Site Plan Review

Site: 27601 Southfield Road
Applicant: Oakland Development, LLC
Plan Date: September 13, 2023
Zoning: VC Village Center District
Parcel ID: 24-14-432-010
Proposal: Commercial Building Renovation

Existing dumpster enclosure from the El Dorado Drive front yard.

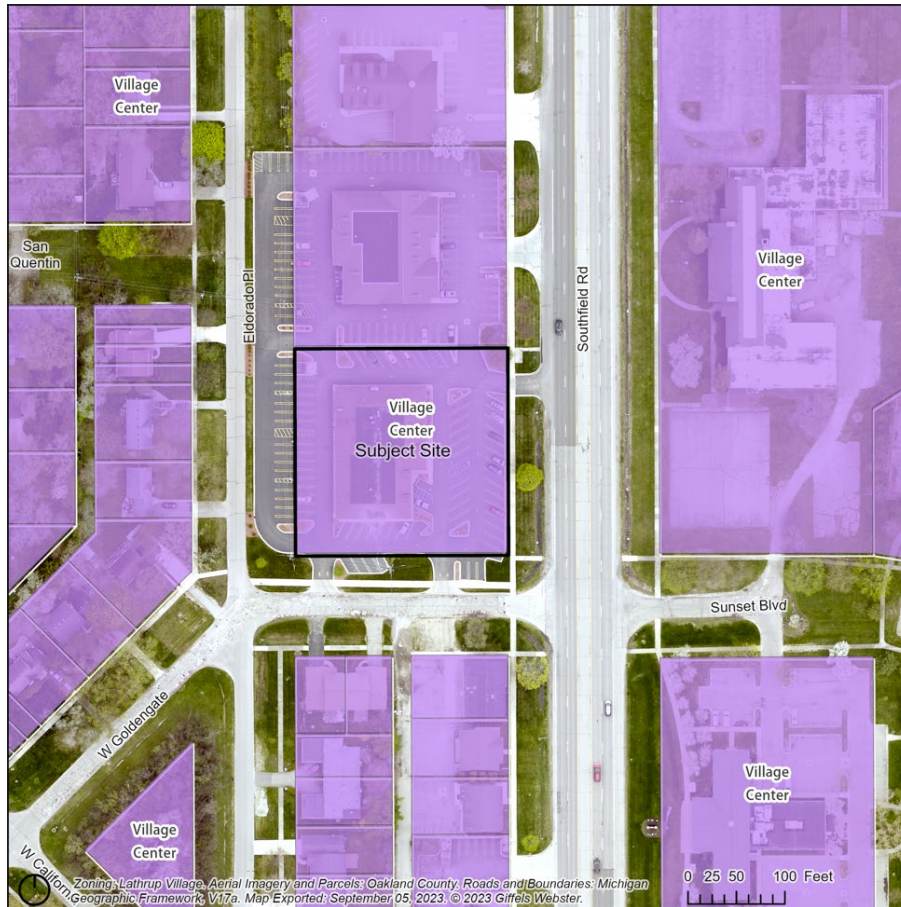
An existing dumpster enclosure is shown on the site plan in the El Dorado Drive front yard. The west side of the site, facing El Dorado Drive, serves as the back of the facility and therefore, the existing dumpster enclosure location is existing nonconforming.

The existing dumpster enclosure, shown in the image above, is partially screened with a number of evergreen trees along a portion of the El Dorado Drive right-of-way. The Planning Commission may consider requiring the property owner to extend the evergreen screening along the El Dorado frontage to soften the views into the property from the street, and more particularly from the single-family residences on the west side of the street. The height of the dumpster enclosure appears to be lower than the dumpster and therefore may be less than the 6' height requirement.
